CROW BUTTE RESOURCES, INC.

Mine Unit 1 Restoration Report
Crow Butte Uranium Project

United States Nuclear Regulatory Commission
Source Materials License SUA-1534

FIGURE 1. Unit 1 Radium-226 Measurements

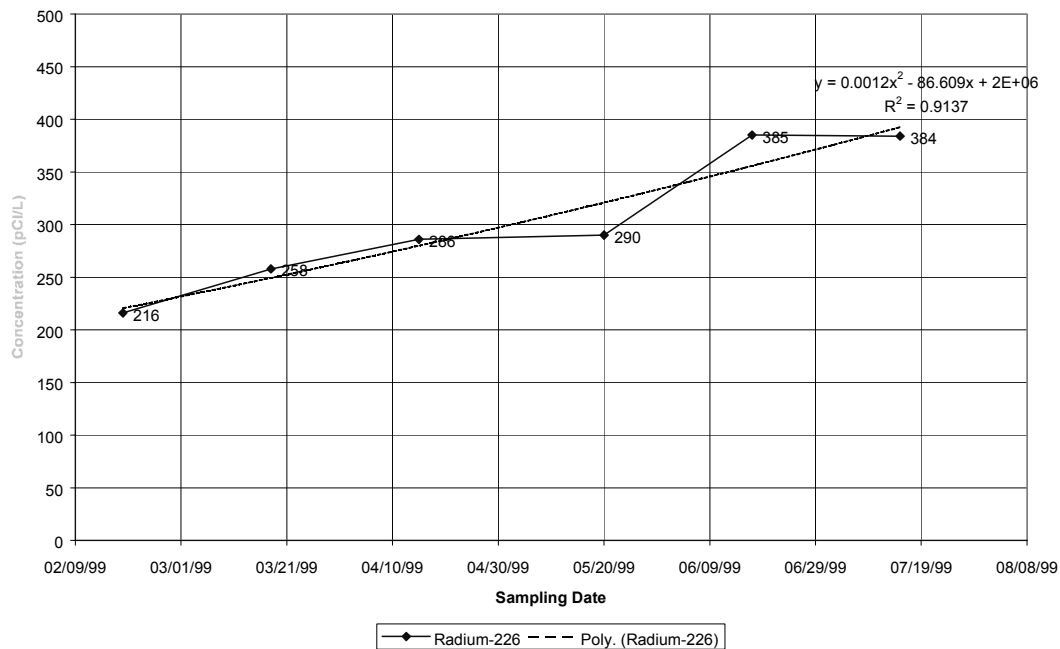
1. **Finding:** Staff’s analysis indicates that concentrations of ammonium, iron, radium-226, selenium, total dissolved solids, and uranium show strongly increasing concentration trends over the stability monitoring period. These trends indicate a reasonable likelihood that license limits would be exceeded in the near future. Other constituents appear to have reached stability, or exhibit such a weakly increasing trend that stability is not a concern. Figures 1, and 2, provide examples of strongly increasing concentration trends in the monitored data during the stability monitoring period. These increasing trends represent a particular concern when a constituent has been restored to the secondary restoration goal, as these two examples were. The secondary restoration standards are greater than the pre-operational baseline concentrations, but are considered protective of the adjacent aquifer beyond the limits of the U.S. EPA designated aquifer exemption boundary. Increasing trends that indicate a potential future exceedance of baseline limits do not represent an immediate concern, since the secondary limits are higher than the baseline limits and are considered protective. Figures 3, and 4, illustrate two constituents that appear to have stabilized during the stability monitoring period. Although Figure 3, shows an increasing trend, this trend is not significant. Figure 4 shows a strongly increasing trend in the early measurements, but the trend dissipated by the time the later data were collected.

1. The licensee's request for Unit 1 wellfield restoration approval should be denied.
2. Decommissioning of Unit 1 should not proceed at this time.
3. Stabilization ground-water monitoring in Unit 1 should be restarted immediately at the monitoring locations described in the January 10, 2000, Restoration Report. The ground-water should be sampled and analyzed for the constituents listed in License Condition 10.3B, SUA-1534, on a schedule of at least 14 days apart. The wellfield restoration shall be considered stable if four consecutive sampling episodes show no strongly increasing concentration trends for all monitored constituents, on a wellfield average, as described in Section 6.1.3, "Standard Review Plan for *In Situ* Leach Uranium Extraction License Applications," NUREG-1569.

Figure 1
Mine Unit 1 Average Uranium Concentration

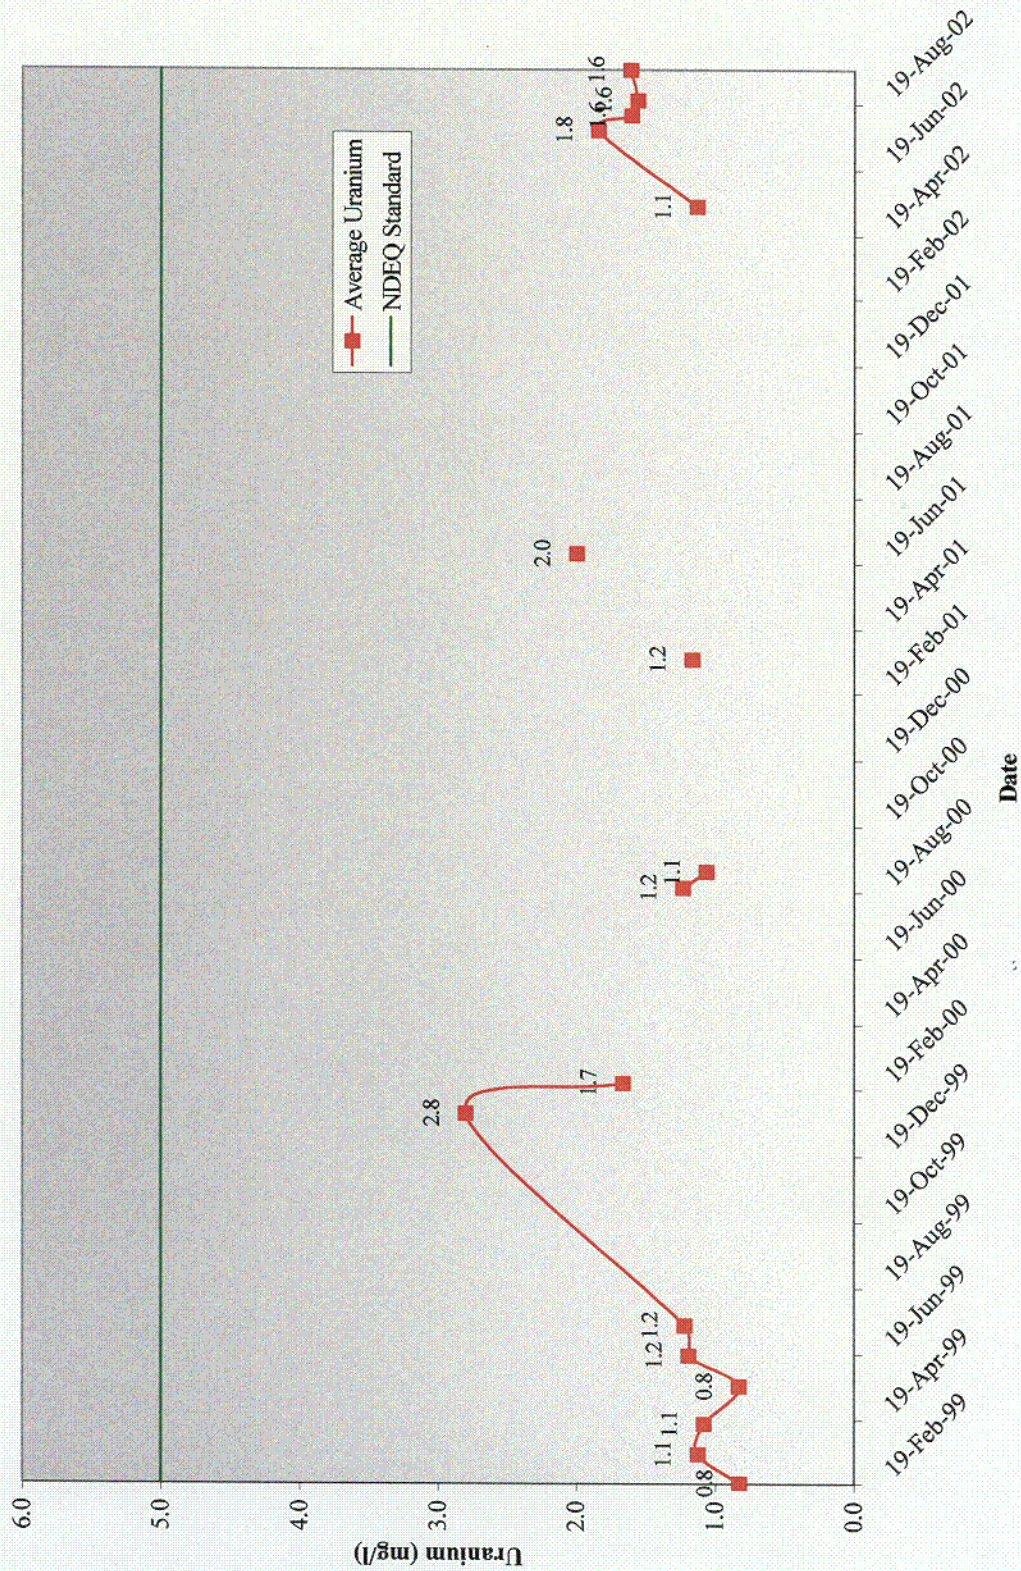
Average Mine Unit 1 concentrations of natural uranium during the stabilization period in 1999 ranged from 1.09 to 2.33 mg/L, with an average concentration of 1.73 mg/L (CBR, 2000). These concentrations compare with the NDEQ restoration standard of 5 mg/L. Figure 1 plots the average uranium concentration for the six representative restoration wells during stabilization monitoring in 1999 and the additional monitoring performed in 2002. The figure also includes additional data obtained by CBR from selected wells beginning in early 2000 through 2002.

As shown in Figure 1, uranium concentrations are stable at concentrations well below the restoration standard of 5 mg/L. The average uranium concentrations for the six representative wells ranged from 1.6 to 1.8 mg/L between June and September 2002, with an average concentration of 1.66 mg/L.

Figure 2
Mine Unit 1 Average Radium Concentration

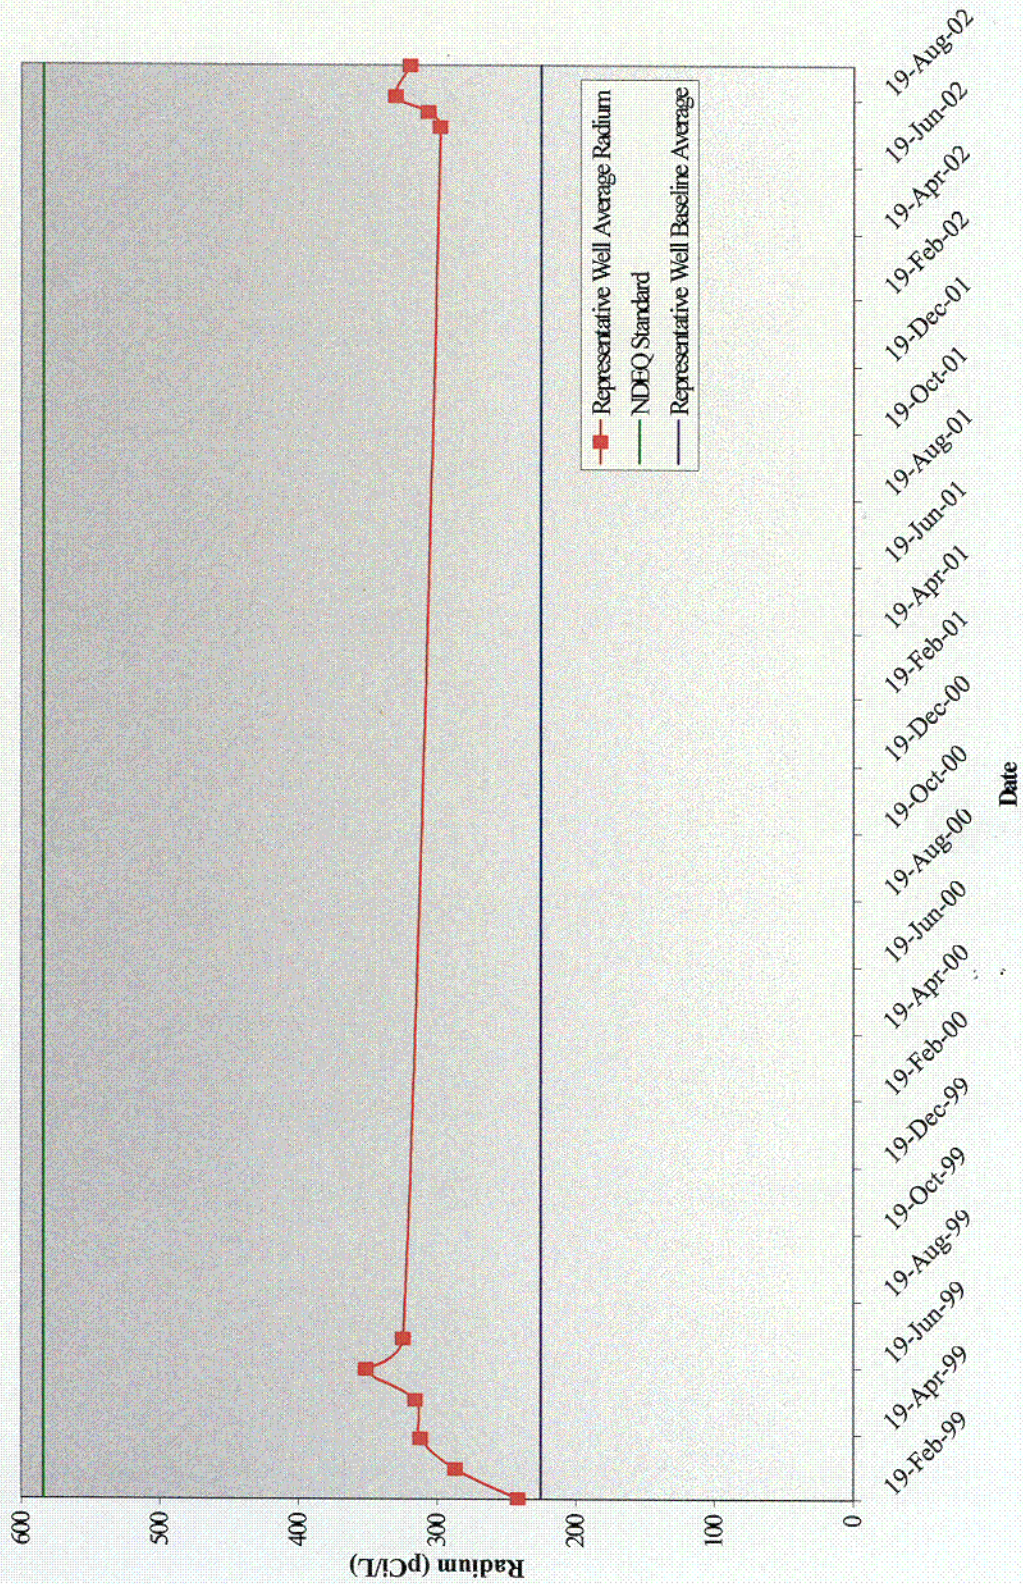
Average Mine Unit 1 concentrations of radium-226 during the stabilization period in 1999 ranged from 216 to 385 pCi/L, with an average concentration of 303 pCi/L (CBR, 2000). These concentrations compare with the baseline average concentration of 230 pCi/L and the NDEQ restoration standard for Mine Unit 1 of 584 pCi/L². Figure 2 plots the average radium-226 concentration from the six representative restoration wells during stabilization and during the additional monitoring period approved by NRC.

As shown in Figure 2, radium-226 concentrations are stable at concentrations well below the restoration standard of 584 pCi/L. The average radium-226 concentrations ranged from 298 to 330 pCi/L between June and September 2002, with an average concentration of 314 pCi/L.

Figure 3
Mine Unit 1 Average Ammonium Concentration

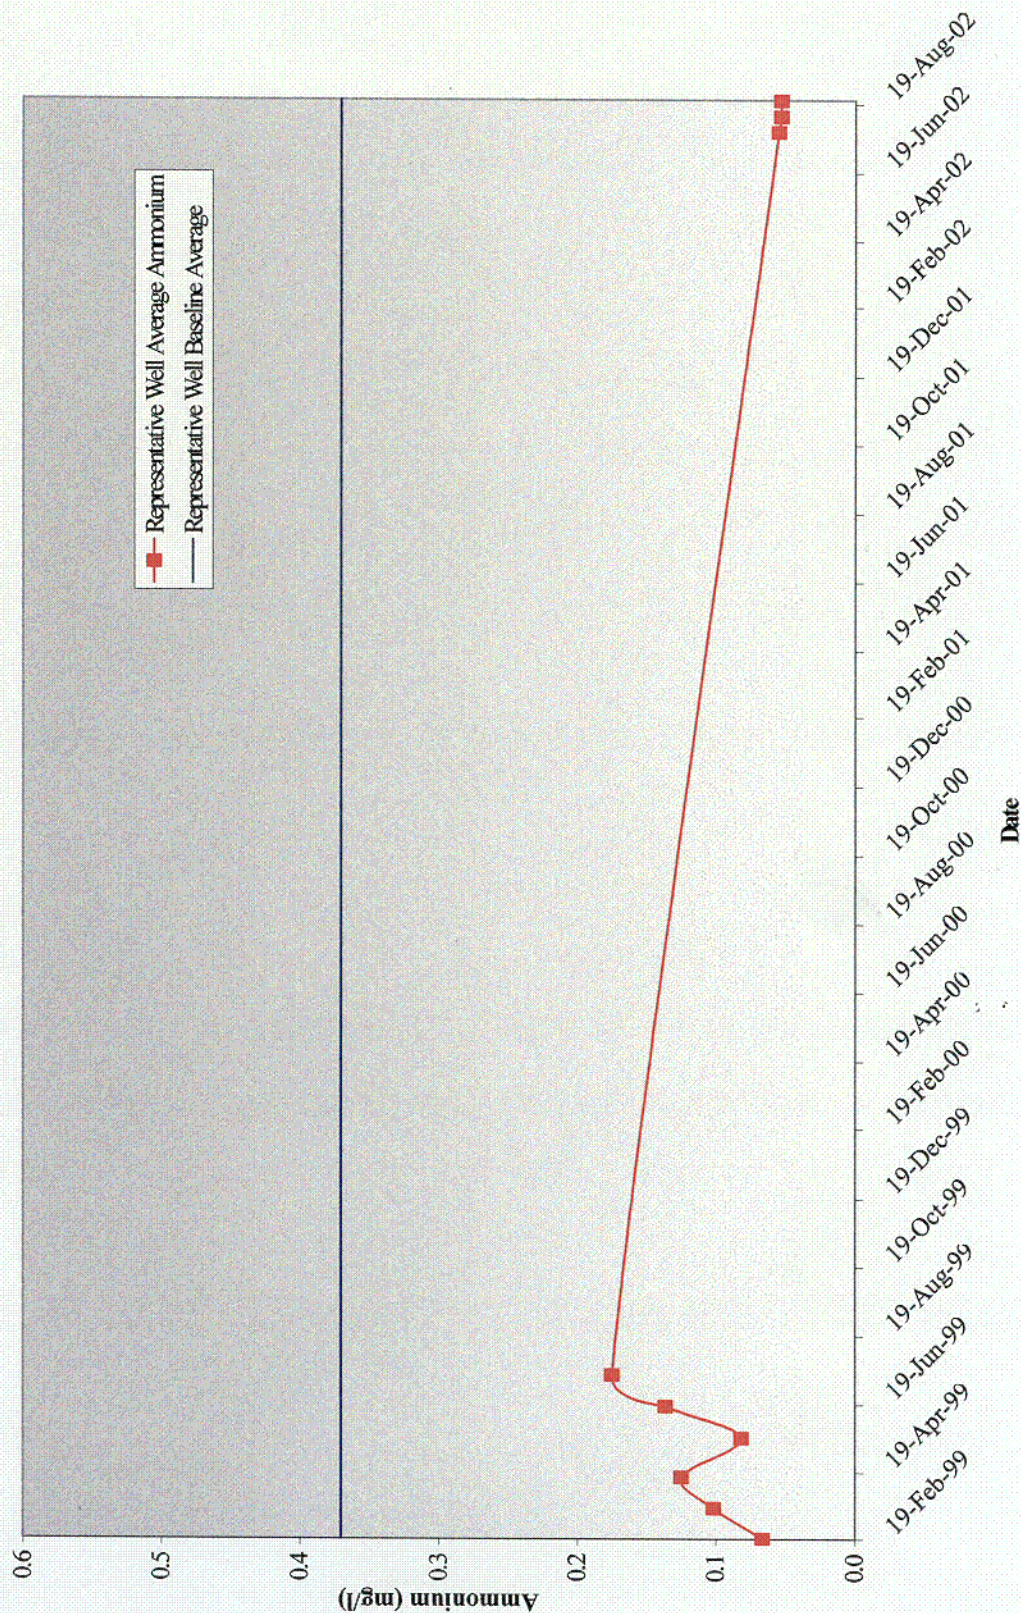
Average Mine Unit 1 concentrations of ammonium during the stabilization period in 1999 ranged from 0.07 to 0.18 mg/L, with an average concentration of 0.12 mg/L (CBR, 2000). These concentrations compare with the baseline average concentration of 0.37 mg/L and the NDEQ restoration standard for Mine Unit 1 of 10 mg/L³. Figure 3 plots the average ammonium concentration from the six representative restoration wells during stabilization and during the additional monitoring period approved by NRC. (Note that the restoration standard of 10 mg/L cannot be plotted due to the useful scale of the graph).

As shown in Figure 3, ammonium concentrations are stable at concentrations well below the premining baseline concentration of 0.37 mg/L. The average ammonium concentrations ranged from 0.05 to 0.06 mg/L between June and September 2002, with an average concentration of 0.05 mg/L. These current concentrations are 0.5 percent of the restoration standard of 10 mg/L.

Figure 4
Mine Unit 1 Average Iron Concentration

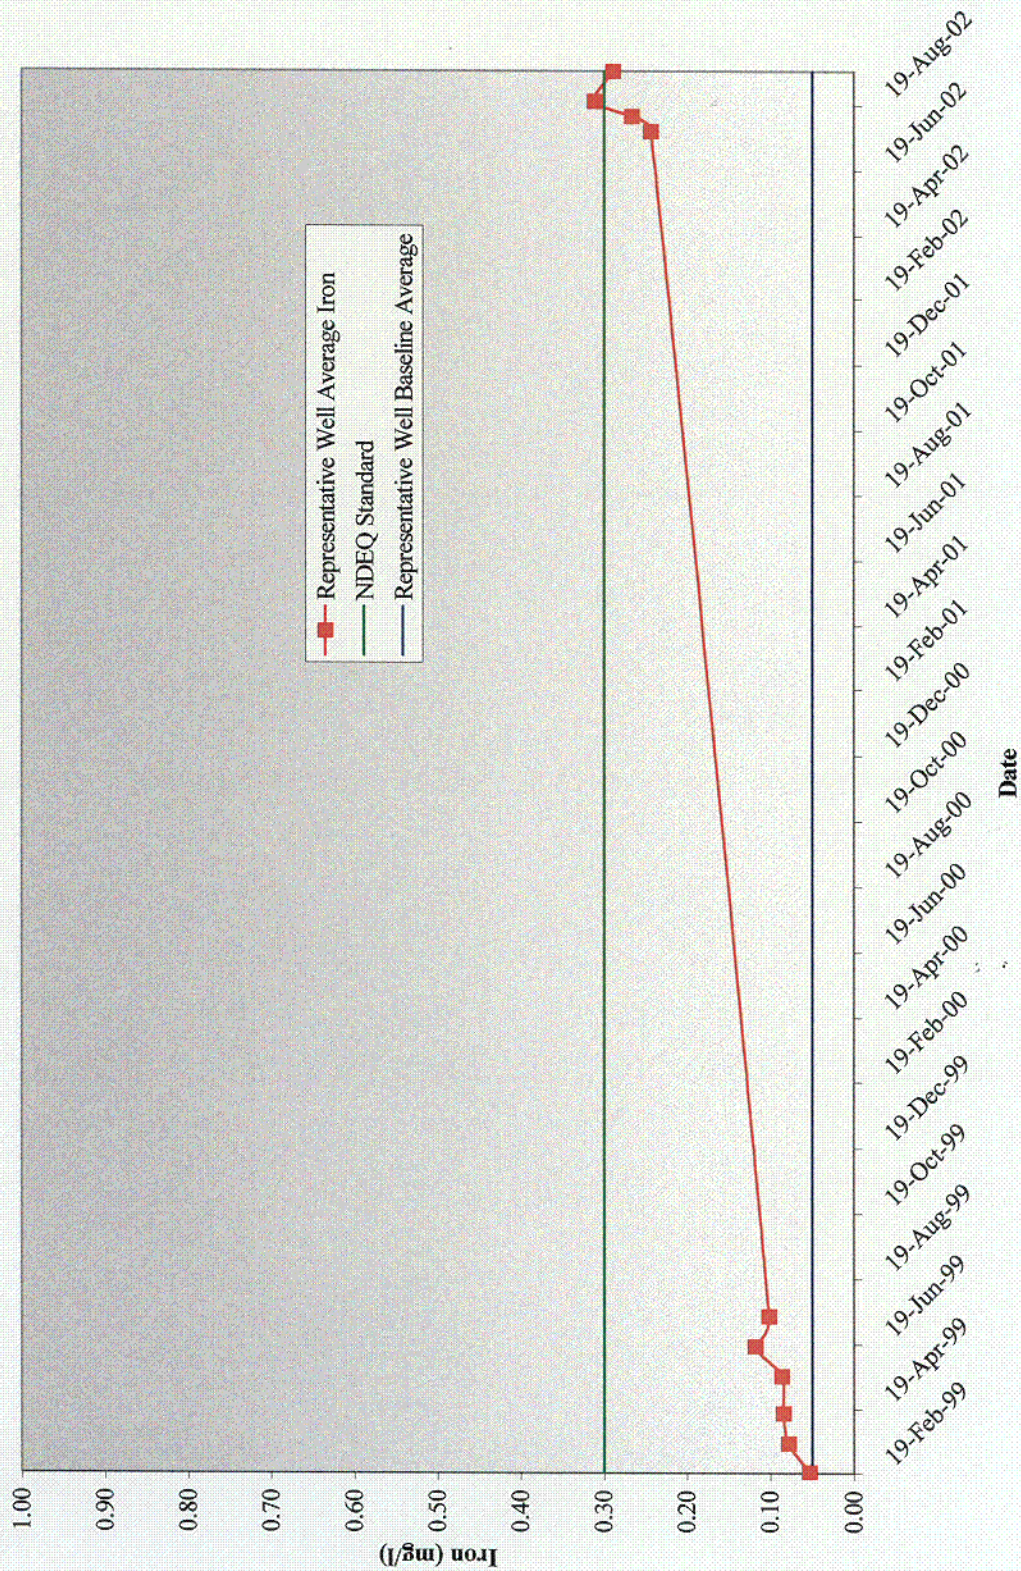
Average Mine Unit 1 concentrations of iron during the stabilization period in 1999 ranged from 0.049 to 0.127 mg/L, with an average concentration of 0.089 mg/L (CBR, 2000). These concentrations compare with the baseline average concentration of 0.044 mg/L and the NDEQ restoration standard for Mine Unit 1 of 0.3 mg/L⁴. Figure 4 plots the average iron concentration from the six representative restoration wells during stabilization and during the additional monitoring period approved by NRC. As shown in Figure 4, iron concentrations have increased since the stabilization period to a concentration that is near the restoration standard. The average iron concentrations ranged from 0.24 to 0.31 mg/L between June and September 2002, with an average concentration of 0.278 mg/L.

Figure 5
Mine Unit 1 Average Selenium Concentration

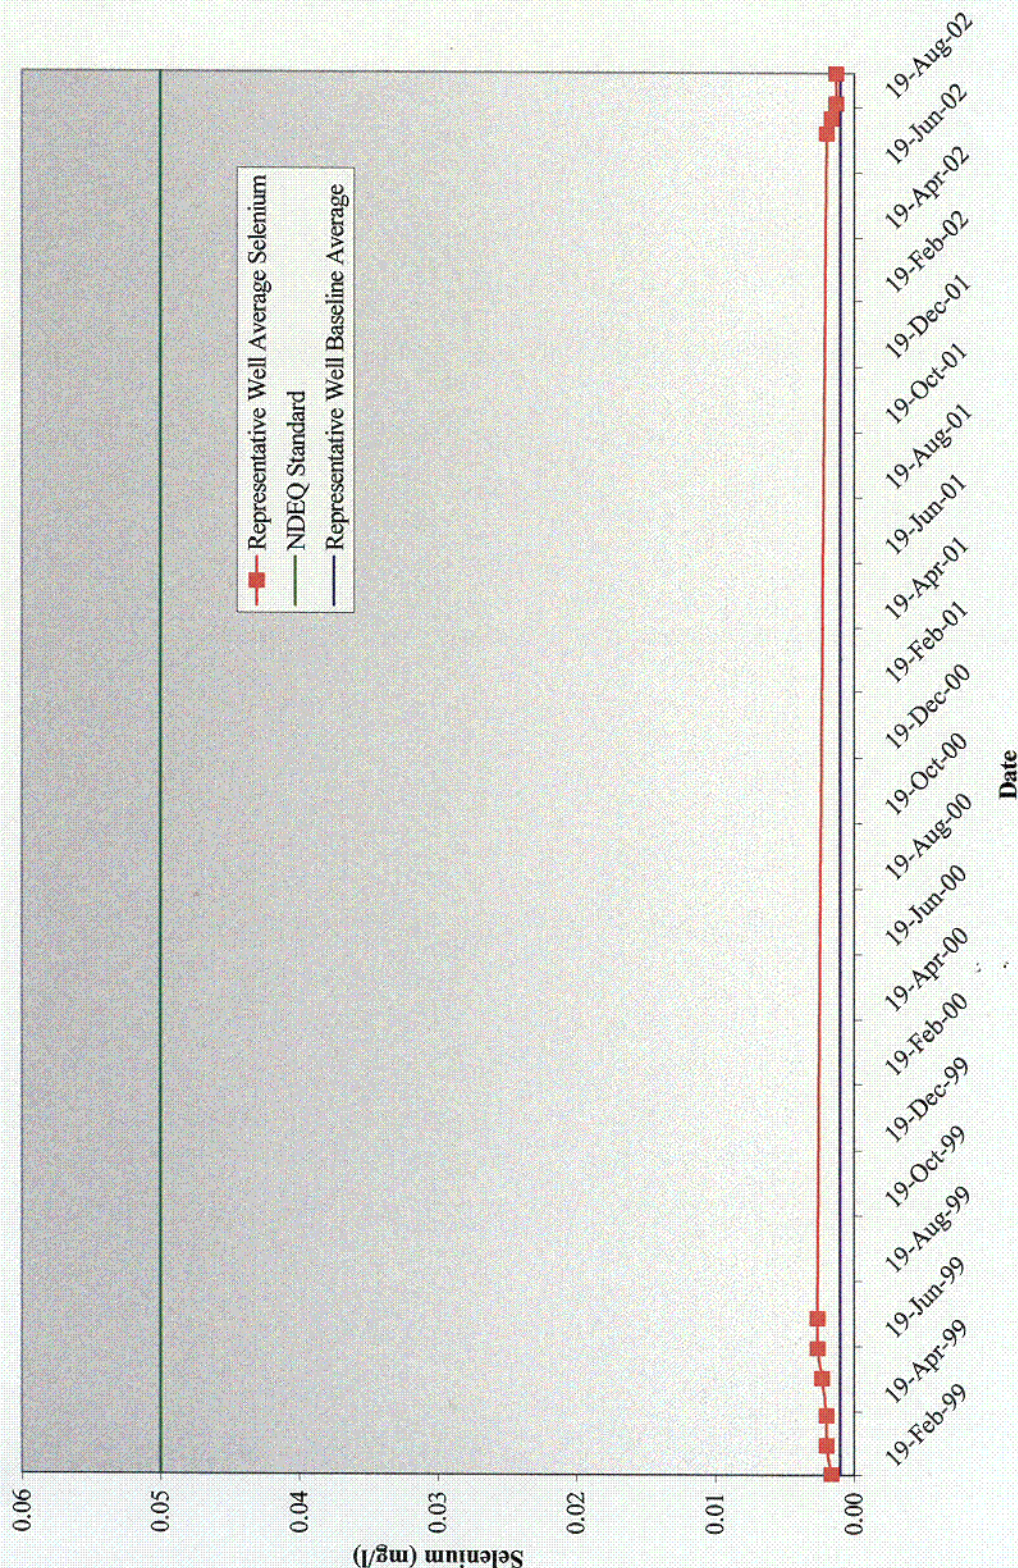
Average Mine Unit 1 concentrations of selenium during the stabilization period in 1999 ranged from 0.001 to 0.003 mg/L, with an average concentration of 0.002 mg/L (CBR, 2000). These concentrations compare with the baseline concentration of 0.003 mg/L and the NDEQ restoration standard for Mine Unit 1 of 0.05 mg/L⁵. Figure 5 plots the average selenium concentration from the six representative restoration wells during stabilization and during the additional monitoring period approved by NRC.

As shown in Figure 5, selenium concentrations are stable at concentrations near baseline and well below the restoration standard of 0.05 mg/L. The average selenium concentrations ranged from 0.0013 to 0.002 mg/L between June and September 2002, with an average concentration of 0.0016 mg/L.
